SERVICE No. 361 BULLETIN

Piper Aircraft Corporation

Subject: Inspection of Elevator Hinge Bracket Reinforcement

Models Affected: PA-31 Navajo

Service Bulletin 361

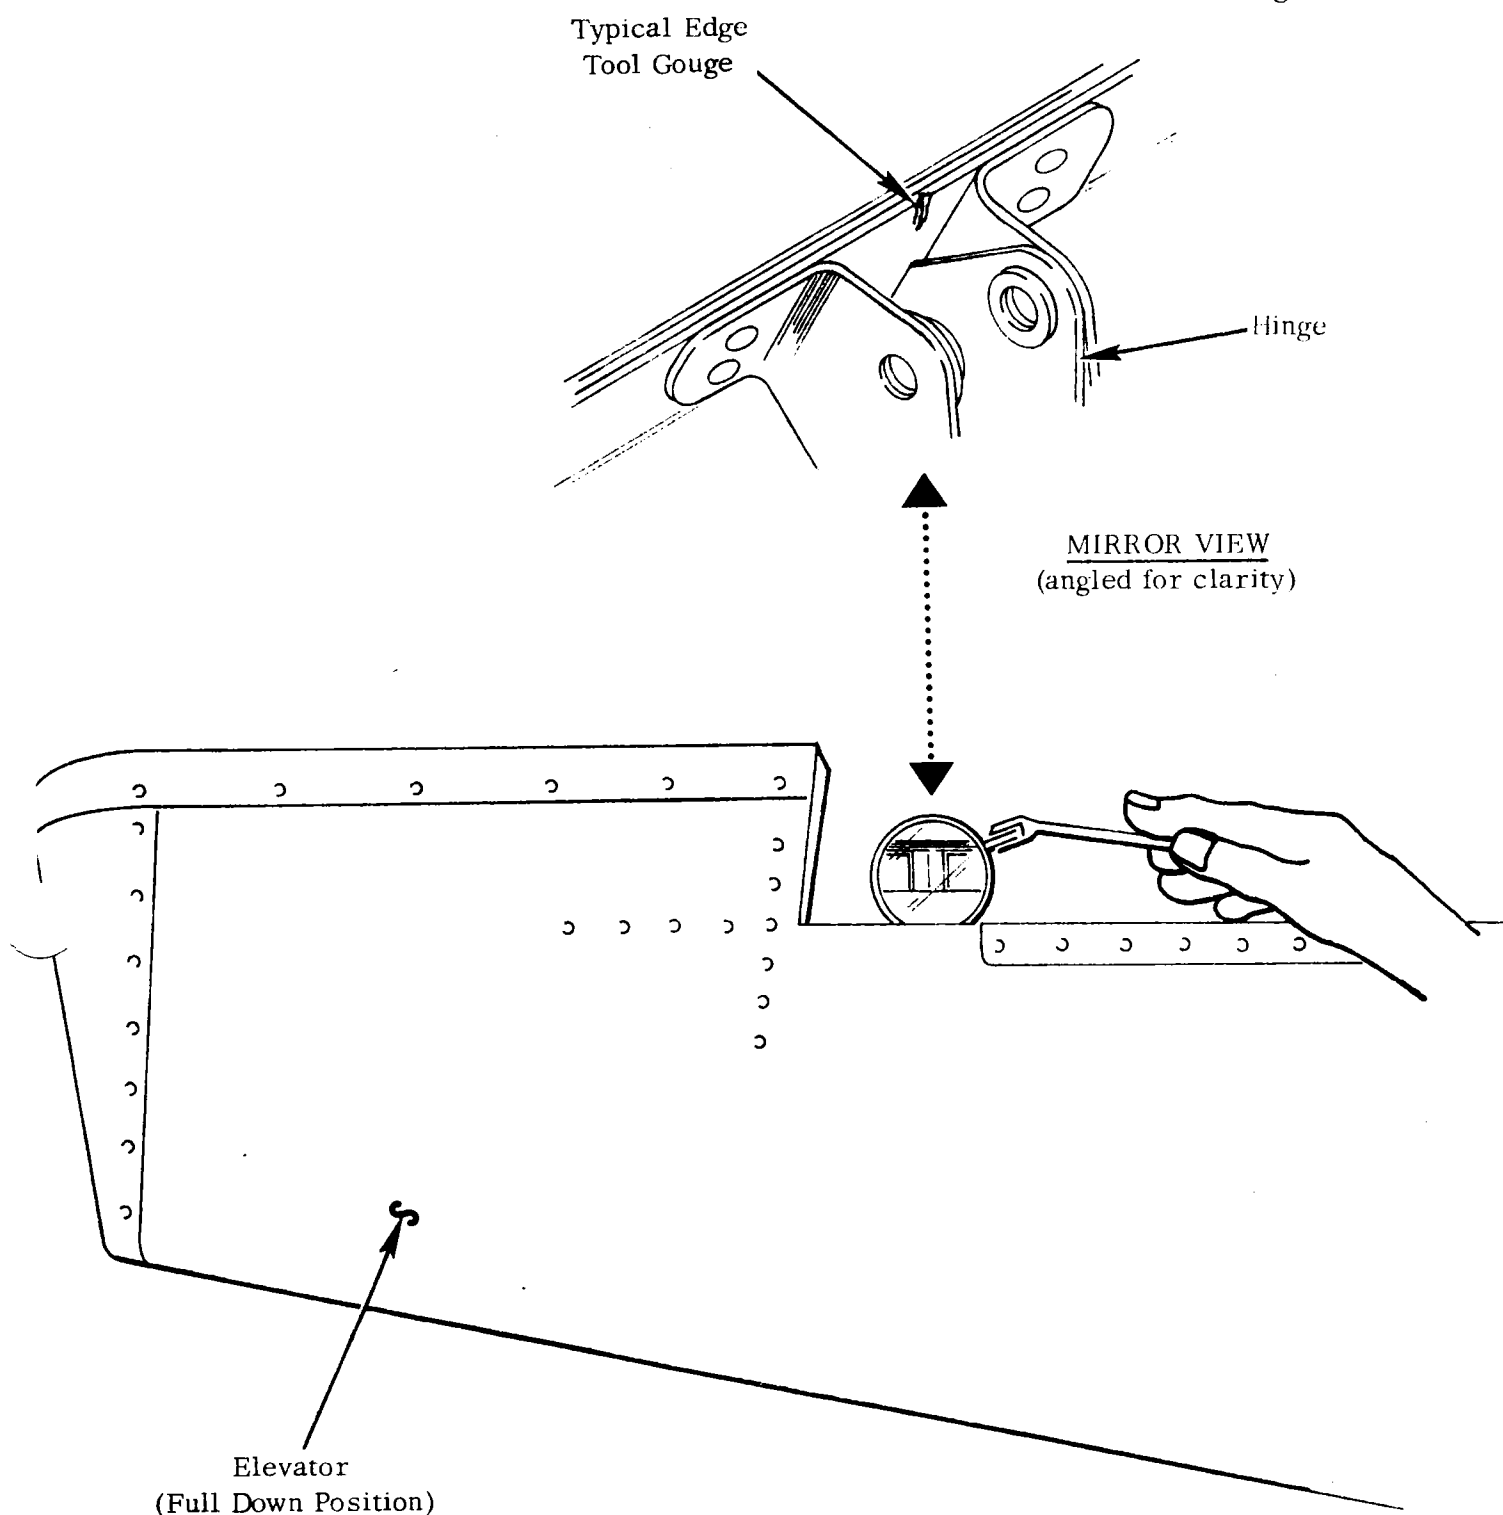
Purpose: A recent report received from the field described damage to the outboard hinge bracket reinforcement area of an elevator assembly on one of the above referenced aircraft. The damage amounted to a tool mark along the edge surface of the hinge bracket reinforcement.

Therefore, it will be necessary to inspect the elevators on the above referenced aircraft in the areas described above to insure that there are no tool marks in the elevator outboard hinge bracket area and to replace elevators should the inspection reveal tool mark damage -- see attached sketch for a general illustration.

1. Place elevators in "full down" position.
2. Stand directly aft of elevator and position mirror as shown for proper view of outboard hinge bracket reinforcement area.
3. Check for tool marks; a pictorial representation of a tool mark is contained on the attached sketch.
4. If no tool marks are observed, no further action is required. Make appropriate log book entry and return aircraft to service.
5. Should tool marks be observed as denoted on the attached sketch, replace affected elevator assembly (see Material Required, below). Make appropriate log book entry.

Stand directly aft of elevator and position mirror as shown for proper view of hinge area.

Material Required: One (1) each (per aircraft) Elevator Assembly, Piper Part No. 43757-18 (left hand) and/or Piper Part No. 43757-17 (right hand), as required per Instructions, above.
